# CROSSROADS NORTH PRELIMINARY PLAN

LOCATED IN THE EAST 1/2 OF SECTION 8, T14S, R65W, OF THE 6th P.M., EL PASO COUNTY, COLORADO

### PRELIMINARY PLAN / LANDSCAPE STANDARDS

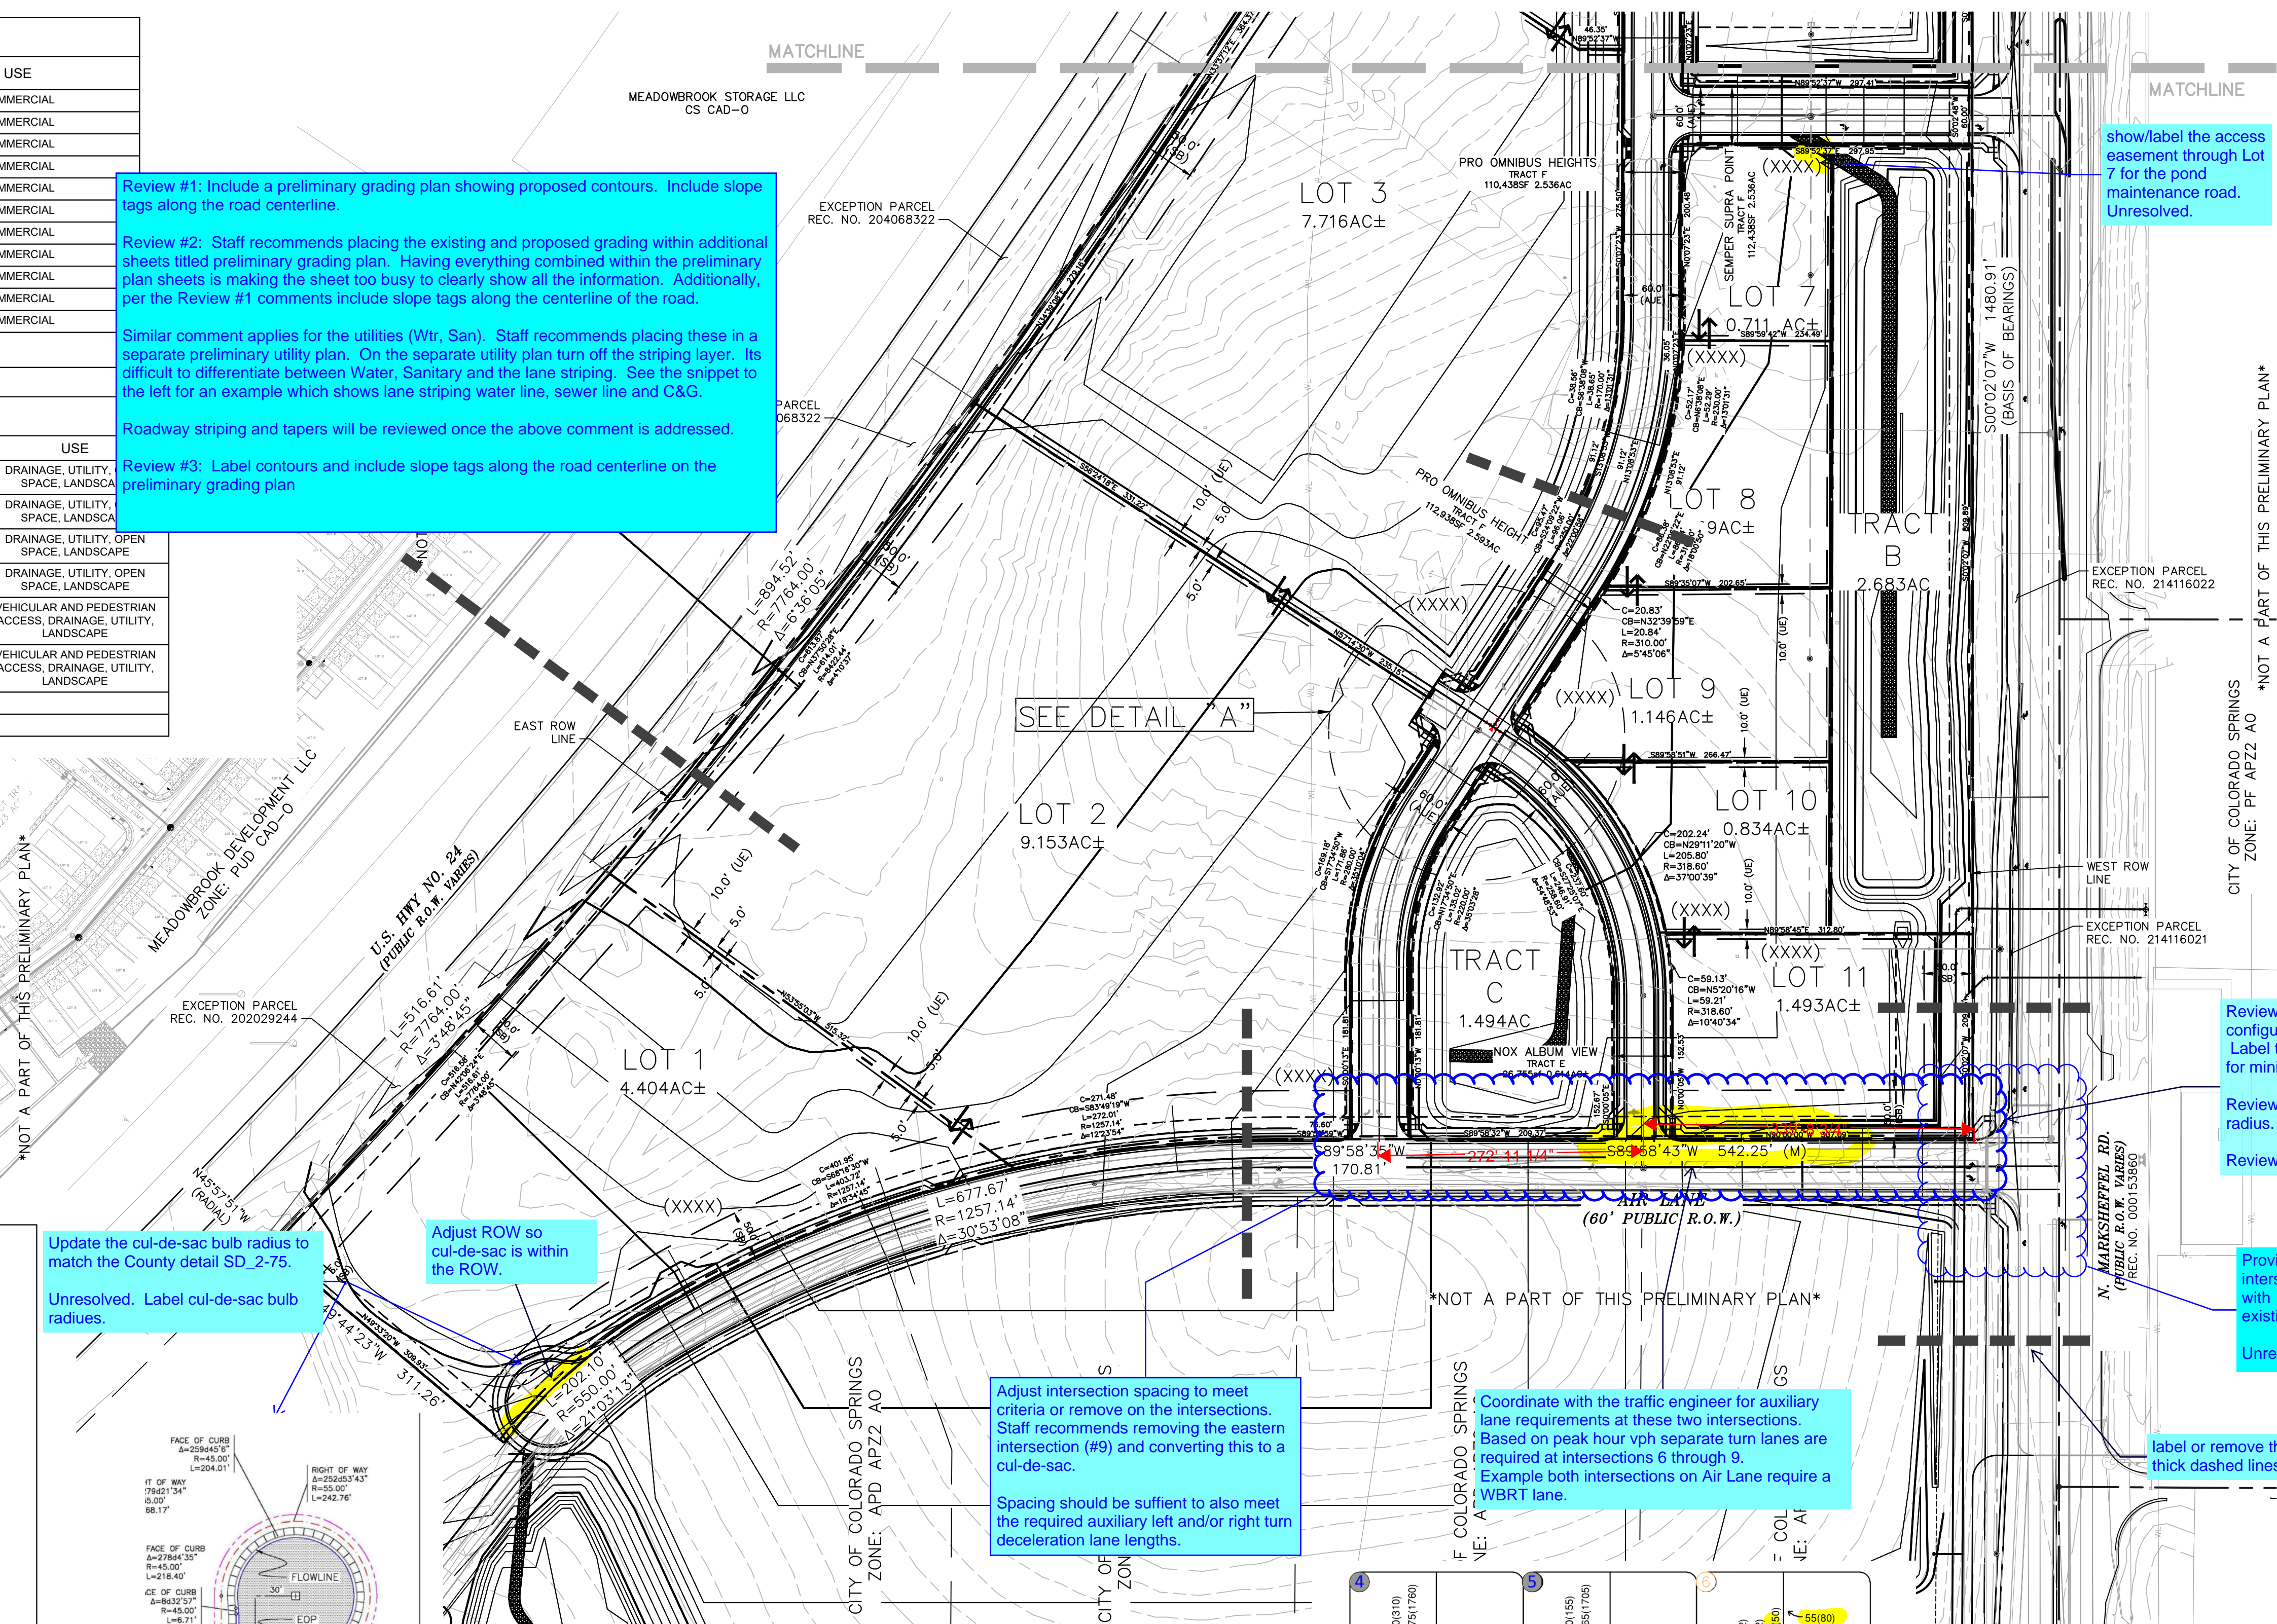
**Review #1:** Include a preliminary grading plan showing proposed contours. Include slope tags along the road centerline.

**Review #2:** Staff recommends placing the existing and proposed grading within additional sheets titled preliminary grading plan. Having everything combined within the preliminary plan sheets is making the sheet too busy to clearly show all the information. Additionally, per the Review #1 comments include slope tags along the centerline of the road.

**Review #3:** Label contours and include slope tags along the road centerline on the preliminary grading plan

Similar comment applies for the utilities (Wtr, San). Staff recommends placing these in a separate preliminary utility plan. On the separate utility plan turn off the striping layer. Its difficult to differentiate between Water, Sanitary and the lane striping. See the snippet to the left for an example which shows lane striping water line, sewer line and C&G.

Roadway striping and tapers will be reviewed once the above comment is addressed.

Update the cul-de-sac bulb radius to match the County detail SD 2-75.

Unresolved. Label cul-de-sac bulb radii.

Adjust ROW so cul-de-sac is within the ROW.

Adjust intersection spacing to meet criteria or remove on the intersections. Staff recommends removing the eastern intersection (#9) and converting this to a cul-de-sac.

Spacing should be sufficient to also meet the required auxiliary left and/or right turn deceleration lane lengths.

Coordinate with the traffic engineer for auxiliary lane requirements at these two intersections. Based on peak hour vph separate turn lanes are required at intersections 6 through 9. Example both intersections on Air Lane require a WBRT lane.

**Review #1:** Show the proposed roadway configuration of Air Lane and the intersection. Label the curb return radius. See Table 2-31 for minimum curb return radius.

**Review #2:** Unresolved. Label the curb return radius.

**Review #3:** Unresolved.

Provide a larger detailed preliminary grading at the intersection. There appears to be drainage issues with two existing culverts, proposed sidewalk and existing roadside ditch.

Unresolved.

label or remove these thick dashed lines.

A STREET LANDSCAPE DETAIL "A" - HIGHWAY 24  
TYPICAL NTS

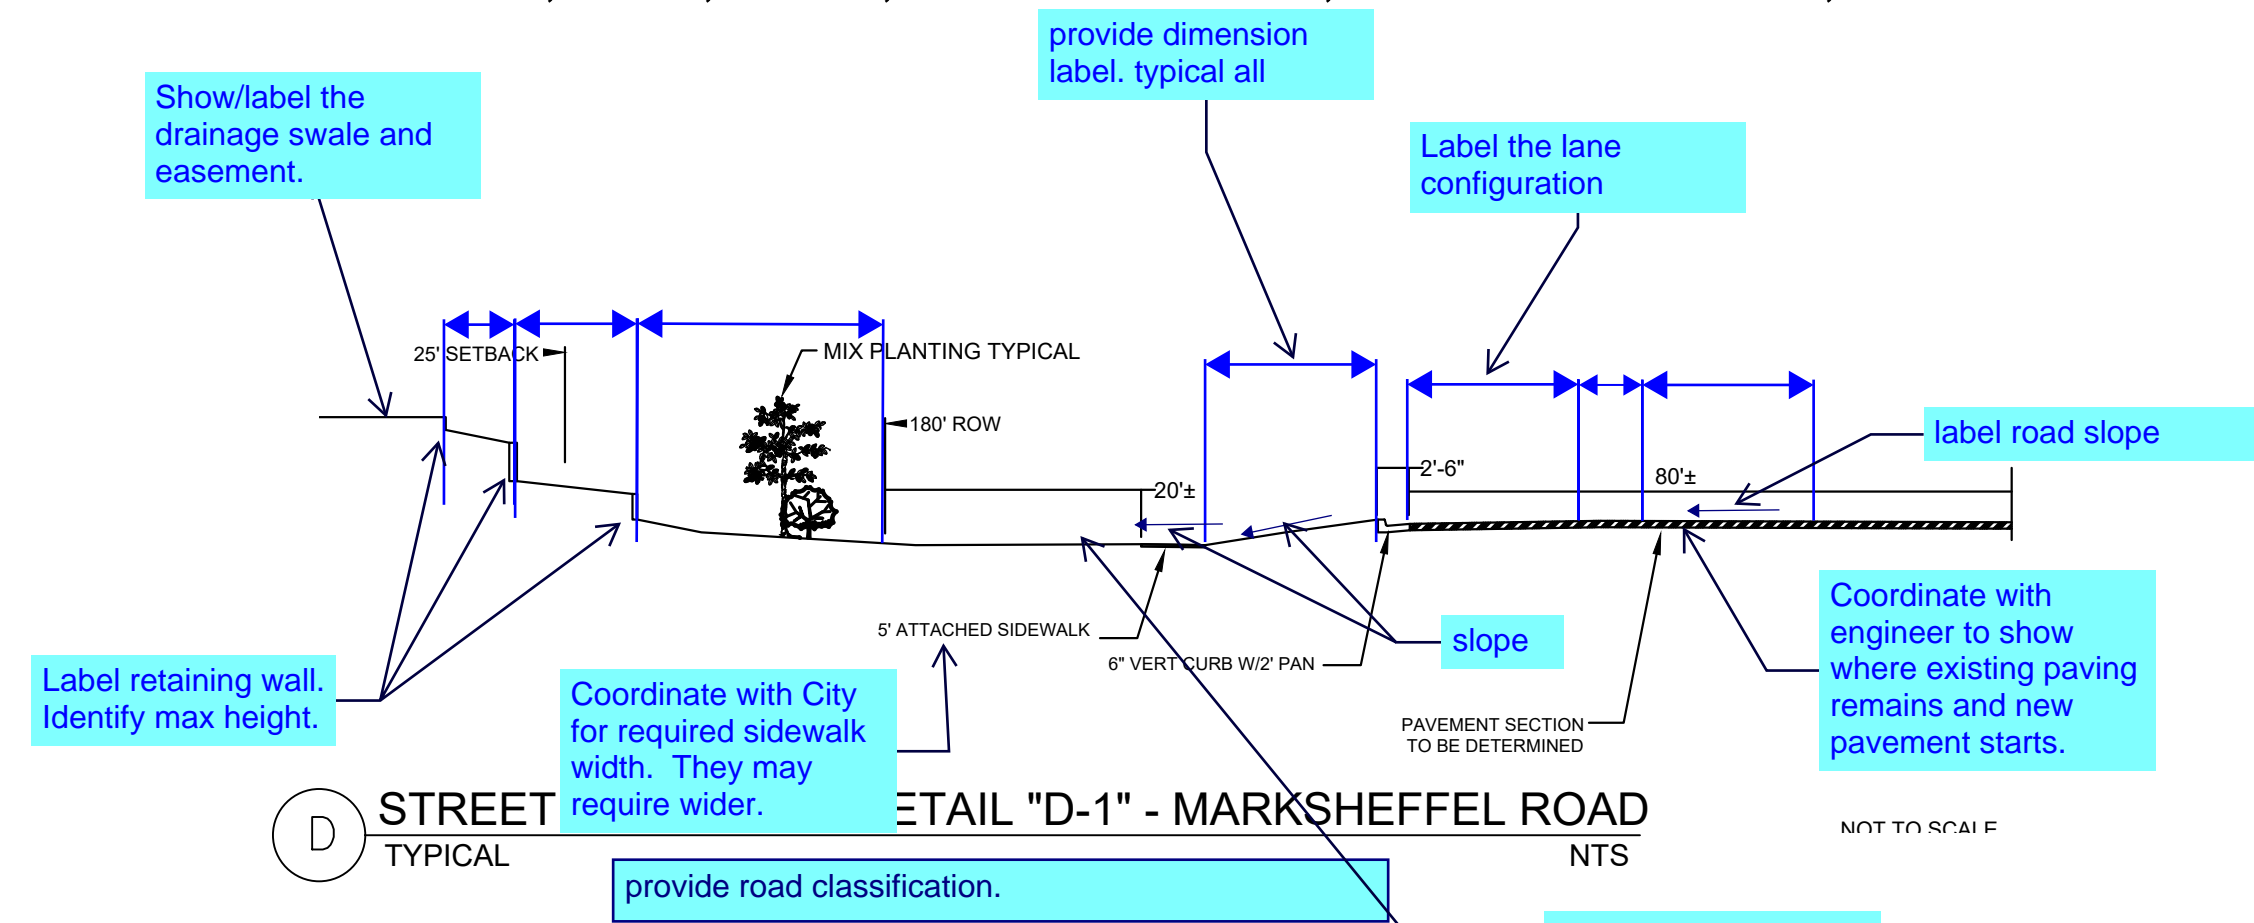
Review #2: identify the max height of the retaining wall.  
Sheet 2 appears to indicate two tiers of retaining wall. Update to reflect the grading plan.  
Review #3: Unresolved.

Review #1: Change from ROW to either AUE or Tract. Adjust to include the entire section within the easement. Same comment applies to section C.

Review #2: Unresolved. Update cross section to match the deviation request cross section. Main difference is the landscape strip, sidewalk location and the addition of P.I.E.

Review #3: Revise to match the cross section per the submitted deviation request for private road cross section. Per the Traffic Study this should be designed as Urban Non-Residential Collector Cross Section.

B STREET AND LANDSCAPE DETAIL "B" - SEMPER SUPRA POINT PRO OMNIBUS HEIGHTS  
TYPICAL NTS

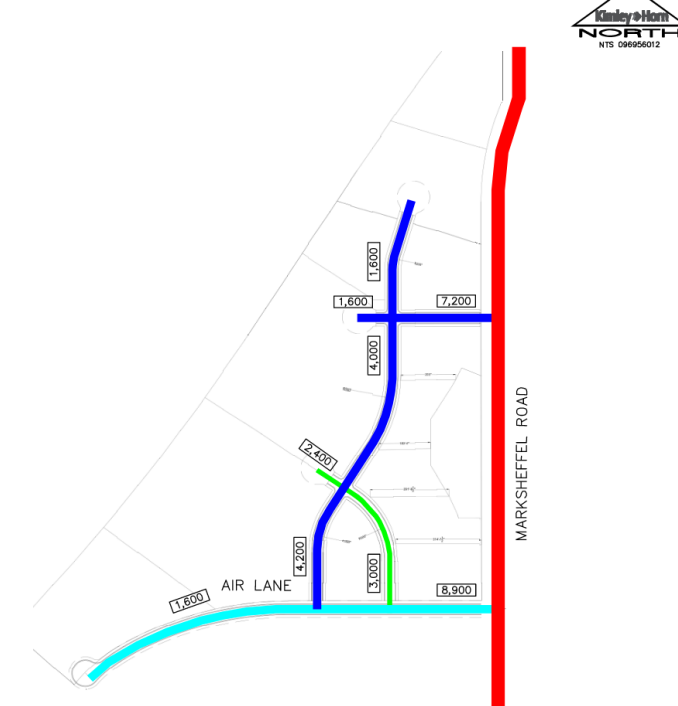
Incorporate comments to the other cross section details on this sheet.

C STREET AND LANDSCAPE DETAIL "C" - AIR LANE  
TYPICAL NTS

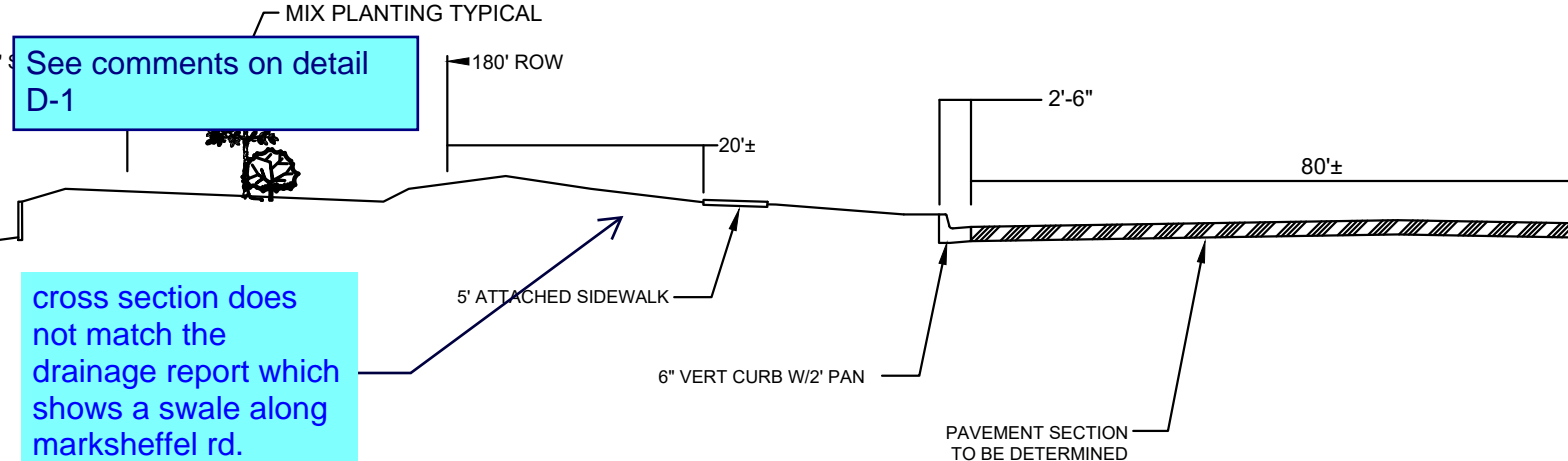
Show/label the drainage swale. The drainage report proposes a drainage channel along Marksheffel Road with bottom width of 10 ft and side slopes of 10:1.

D LANDSCAPE DETAIL "D-3" - MARKSHEFFEL ROAD  
TYPICAL NTS

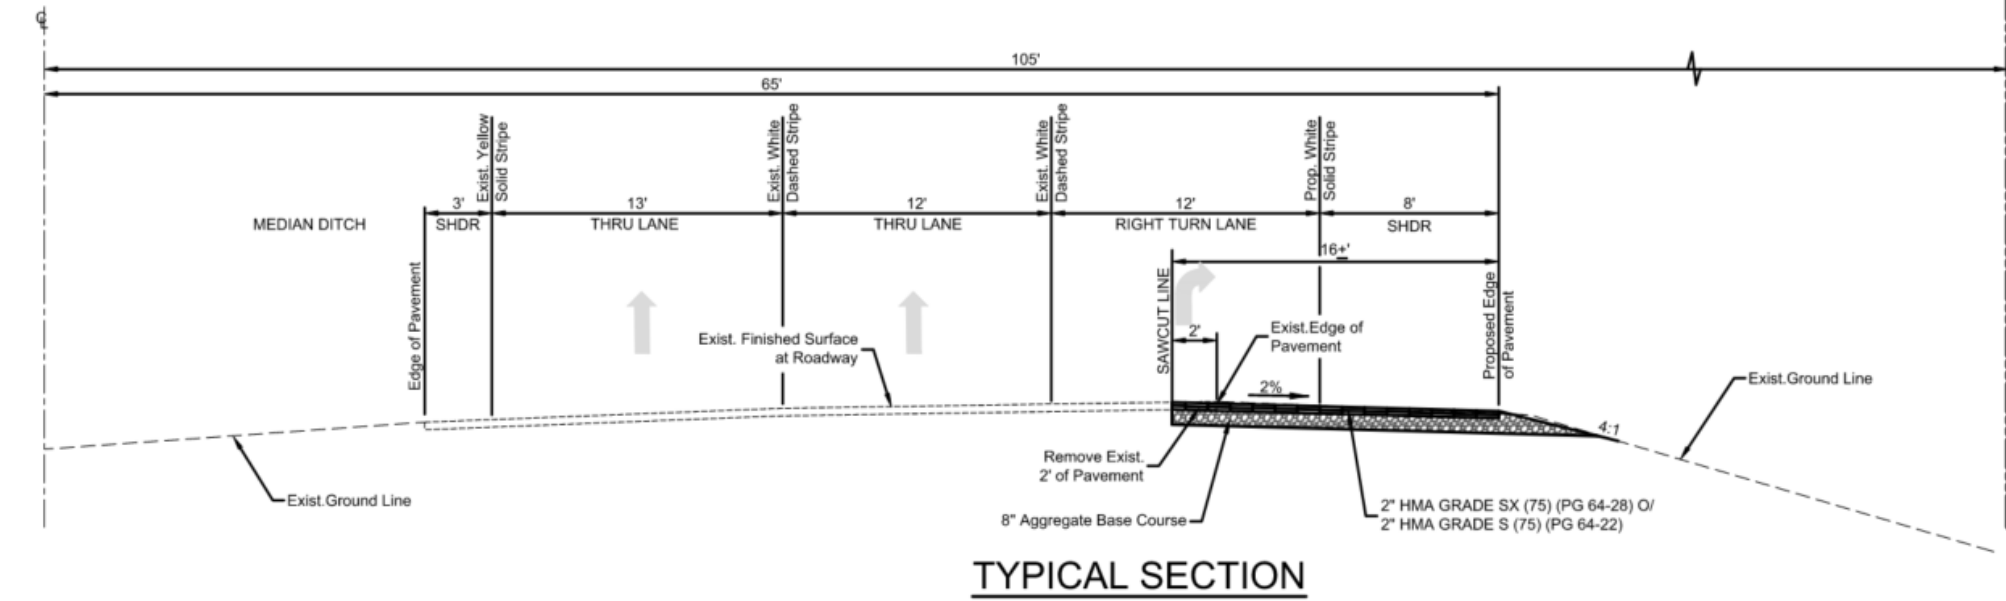
Revise cross section. This needs to identify what is new and what is existing. Multiple cross section needed. One where a new southbound Right turn is added. Another where a northbound left turn is proposed. See snippet to the right for example. Unresolved.

cross section does not match the drainage report which shows a swale along marksheffel rd.

Revise. Marksheffel is Urban Principle Arterial.
